## COOPER NUCLEAR STATION

## AMENDMENT TO FACILITY OPERATING LICENSE

Amendment No. 120 License No. DPR-46

# ATTACHMENT TO LICENSE AMENDMENT NO. 120

Figure 3.6.1.a Minimum Temperature for Non-Nuclear Heatup or Core Cooldown Following Nuclear Shutdown

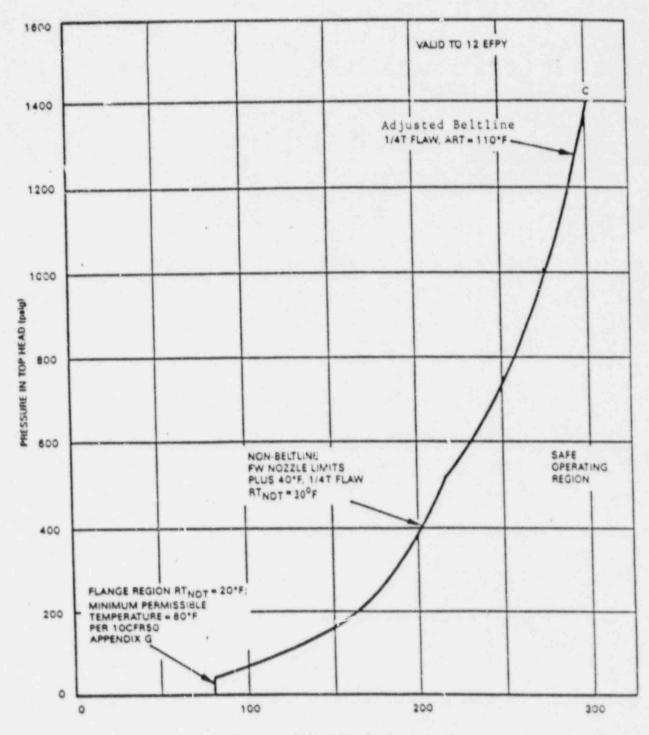
The adjusted reference temperature (ART) of a beltline material is defined as the initial RT<sub>NDT</sub> plus the RT<sub>NDT</sub> shift due to irradiation. The curves of Figures 3.6.1 a and 3.6.1.b reflect a beltline ART of 110°F, making them valid for operation up to 12 EFPY. Figure 3.6.2, the pressure test curve, includes curves with ART values for 8, 10 and 12 EFPY to provide more flexibility in pressure testing. Figure 3.6.2 also has a separate curve for the bottom head region. The bottom head curve does not shift with increased operation. Therefore, the bottom head temperature can be monitored against lower temperature requirements than the beltline during pressure testing.

Figure 3.6.1.b Minimum Temperature for Core Operation (Criticality) -Includes 40°F Margin Required by IOCFR50 Appendix G

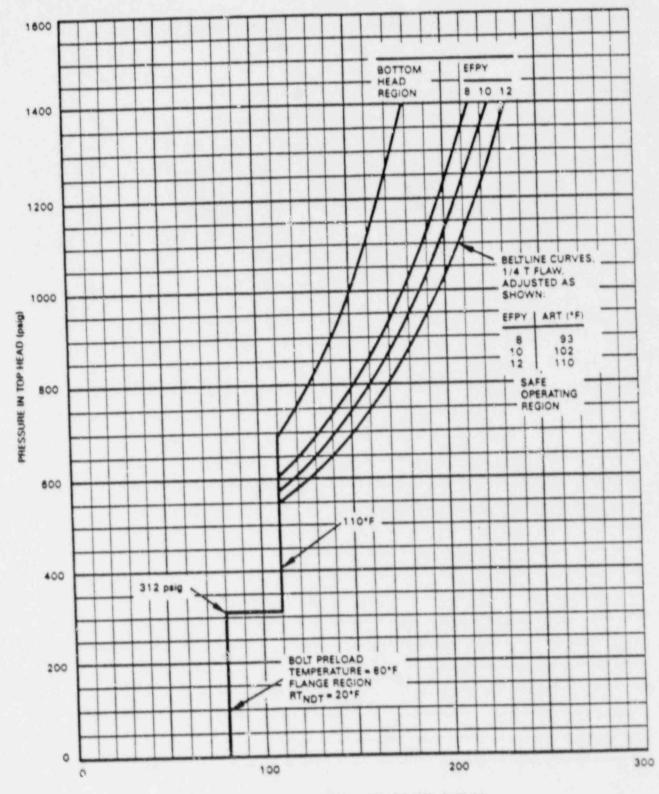
The temperature versus pressure limits when critical which are presented in Figure 3.6.1.b assure compliance with Appendix G of 10CFR50.
